Well Name: POKER LAKE	Well Location: T24S / R30E / SEC 8 / SESW /	County or Parish/State: EDDY / NM
Well Number: 59	Type of Well: CONVENTIONAL GAS WELL	Allottee or Tribe Name:
Lease Number: NMLC068431	Unit or CA Name: POKER LAKE INT MORROW	Unit or CA Number: NMNM71016B
US Well Number: 3001524196	Well Status: Producing Gas Well	Operator: XTO PERMIAN OPERATING LLC

Notice of Intent

Type of Action: Plug and Abandonment

POKER_LAKE_59__2751110__COA_AND_PROCEDURE_20230921142024.pdf

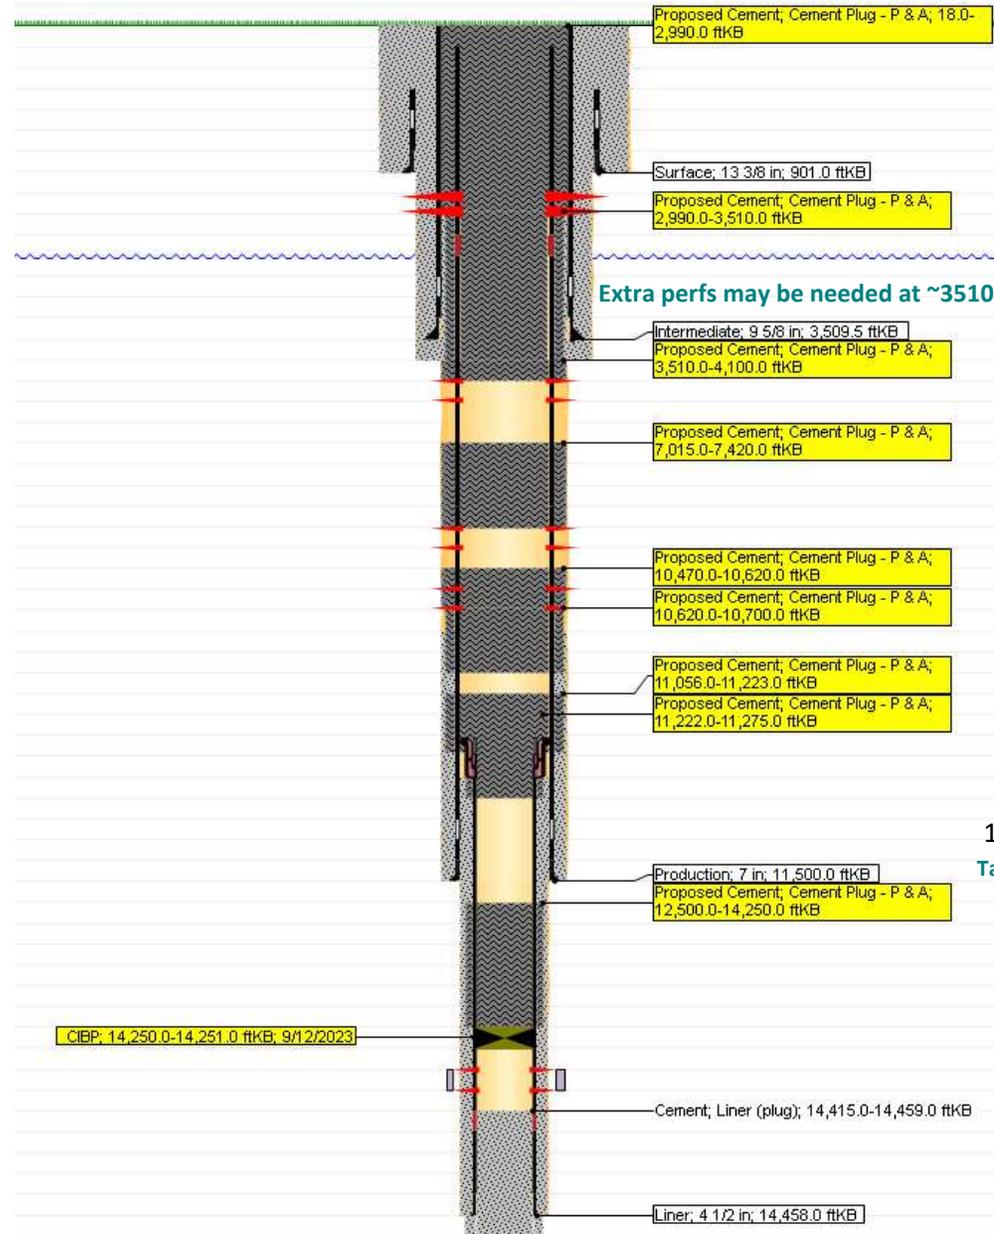
T/Perf ~~12,297'~~

14,297'

Extra perfs may be needed at ~3510'

Spot plug from 3,400 to 2,990'.
Perf at 2,980'. Squeeze cement from 2,980' to surface.

WOC and Tag after spot.

Perf and sqz plug from 4,100-3,400' (T/Delaware, 3,000' rule, TOC) WOC and Tag

Perf and sqz plug from 7,470 to 7,015'. (T/Bone Spring)

Perf and sqz plug from 10,700 to 10,470'. (TOC, T/Wolfcamp)

Spot 40 sks Class H cmt from 11,275 to 11,056'.

11,550-11,056 Shoe Plug, WOC Tag

Pressure test CIBP at 14,250'.
Spot 150 sks Class H from 14,250- 12,500'.

500psi, 30mins for PT
